Stakeholder Comments

Contingency Modeling Enhancements Issue Paper

Submitted by	Company	Date Submitted
Wei Zhou – (626)302-3273 Aditya Chauhan – (626) 302-3764	Southern California Edison	April 9, 2013

Figure 1: System in CAISO's example

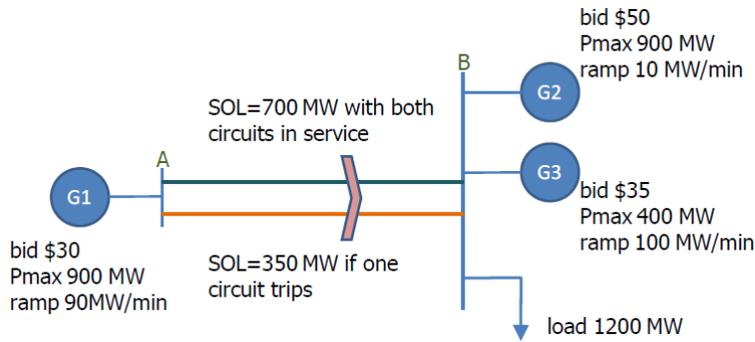
Consider the same example in the CAISO Issue Paper (as shown below), assume the pre-contingency flow is 700MW on Path A-B. Under post-contingency, the flow needs to be reduced to 350MW within 30 minutes.

Under the CAISO's proposal, the solution is to dispatch G2 at 250MW and G1 at 250MW. The "corrective capacity" for G2 is 200MW and for G1 is 150MW. As shown in Table 3 in the issue paper, also duplicated below, G2 will receive a revenue of \$12,500 for the 250MW energy dispatch, and a revenue of \$0 for its "corrective capacity" (based on opportunity cost) or a revenue of \$3,000 for its "corrective capacity" (based on locational capacity-energy mixed price). The total revenue for G2 will be at least \$12,500.

Under the CAISO's solution, there would be no incentives for G2 to advance its technology and improve its ramping rate. The limited ramping capability of G2 contributes to the problem and if G2 were to improve that ramping, the problem may not exist, hence, G2 would not be paid. To illustrate the point, below is a scenario to show that the revenue of G2 will reduce if G2 improves its ramp rate.

Figure 2: Same system except now G2 has improved its ramp rate

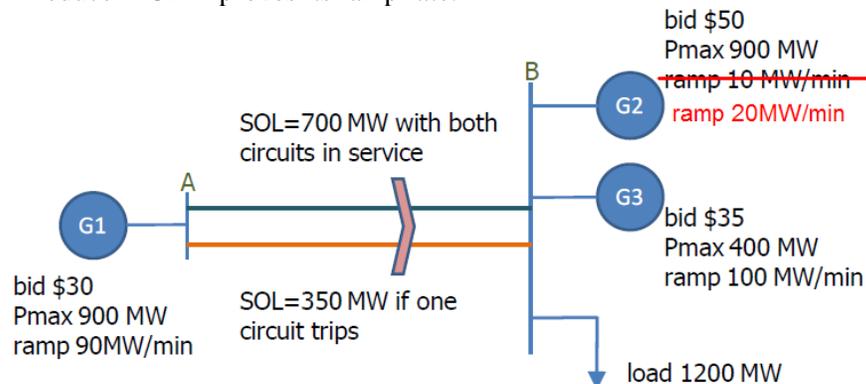
As G2 increases its ramp rate to 20/MW/min, after the N – 1 – 1 contingency occurs, G2 can dispatch up by 350MW within 17.5min. So even considering the N – 1 – 1 contingency, the dispatch solution will be the same as the solution without considering the N – 1 – 1 contingency. The solution without considering the N – 1 – 1 contingency is shown in Table 1 in the CAISO issue paper, duplicated below. G2 is dispatched at 100MW and receives revenue of \$5,000 for energy. Notice the “corrective capacity” for G2 is 0MW, even though G2’s capacity beyond the energy, which is 800MW (Pmax 900MW – 100MW), is readily available to the system should the contingency occur.

The table below summarizes the reduced revenue for G2 after it improves its ramp rate from 10MW/min to 20MW/min under the CAISO current proposal.

In summary, under the CAISO’s proposal, the revenue for G2 will reduce by at least \$7,500 after it improves its ramp rate. The situation is worse if G2 is paid for its “corrective capacity” based on LMCP. Therefore it is doubtful that the CAISO’s proposal incentivizes flexible capacity with faster ramp rate.
